URGENT: FIELD SAFETY NOTICE – MMS-20-3893

BD BodyGuard™ Duo Infusion Pump

BD BodyGuard™ Duo Infusion Pump – Software Upgrade

Situation 1: Issue if a dose is paused in Intermittent program

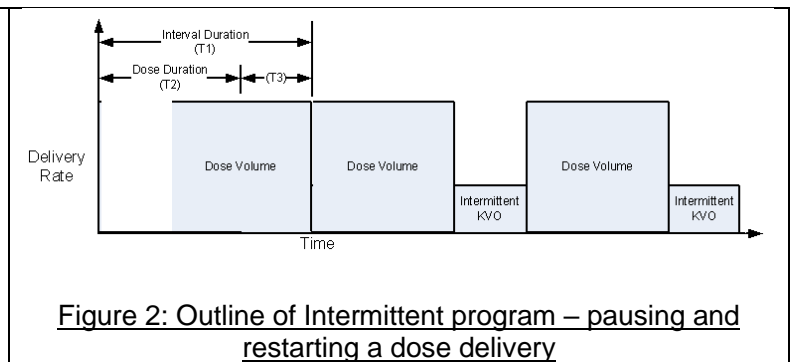
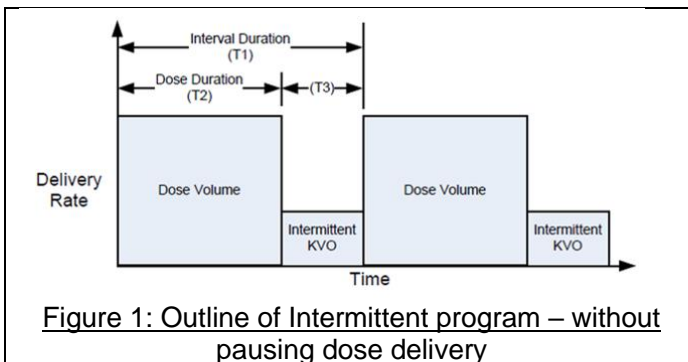
Issue: In Intermittent program only, pausing a dose delivery before the programmed volume has been delivered, could administer two consecutive intermittent bolus doses right after another, leading to an over infusion.

If the pump is turned off during intermittent program, the internal clock continues to monitor the timing of the infusion. Refer to Figure 1 below for an outline of the intermittent program. Basically, the pump will try to keep the interval time (T1) consistent across the infusion program. A software upgrade will be rolled out by BD to ensure that any pause of the dose duration (T2) is added to the interval duration (T1). Until then BD advises Users of the following, if using the Intermittent Program:

- If the pump is stopped during a dose (T2), the operator will be able to resume the remaining time. The pump will keep the interval time (T1) fixed. In the case of a short interval time, the KVO time (T3) will be reduced by the time of the interruption (Figure 2).
- If the pump is stopped during a dose (T2) and restarted after the next scheduled dose time has passed, the pump will start the next dose immediately from the beginning followed by a complete interval as set by the operator. It will not administer the remaining previous dose.
- If the pump is stopped during the Intermittent KVO (T3), the user can restart the pump any time before the next scheduled dose without impacting the infusion program. If the pump is restarted after the next scheduled dose, the pump will start with the next dose immediately followed by a complete interval (T3).

- BD will roll out a software upgrade and revised DFU for the BodyGuard™ Duo Infusion pump
 - This software will update the Intermittent program to ensure that if the Dose Duration (T2) is paused the overall interval duration (T1) will be increased by the amount of time of this pause.

Situation 2: Incorrect alarm priority for EOI (End of Infusion) with KVO (Keep Vein Open)

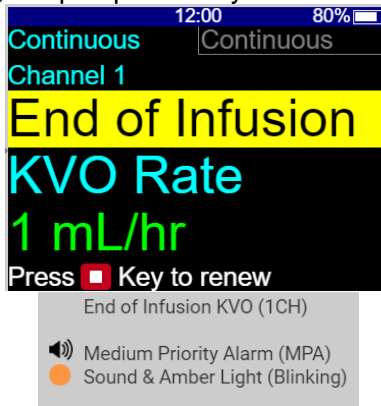
Issue: In BodyGuard™ Duo pumps, the EOI (End of Infusion) with KVO (Keep Vein Open) triggers a medium priority alarm instead of high priority alarm, as specified in DFU. The current medium priority alarm may also cause confusion with NEOI (Near End of Infusion) which is a low priority alarm; both have the same auditory signal as per 60601-1-8.

In the case of End of Infusion with KVO, the pump currently alarms as a medium priority alarm:

Once the KVO has been completed, a high priority End of Infusion alarm is activated:

- BD will roll out a software upgrade and revised DFU for the BodyGuard™ Duo infusion pump
 - This software will update the alarm priority as high for the EOI (End of Infusion) with KVO (Keep Vein Open)
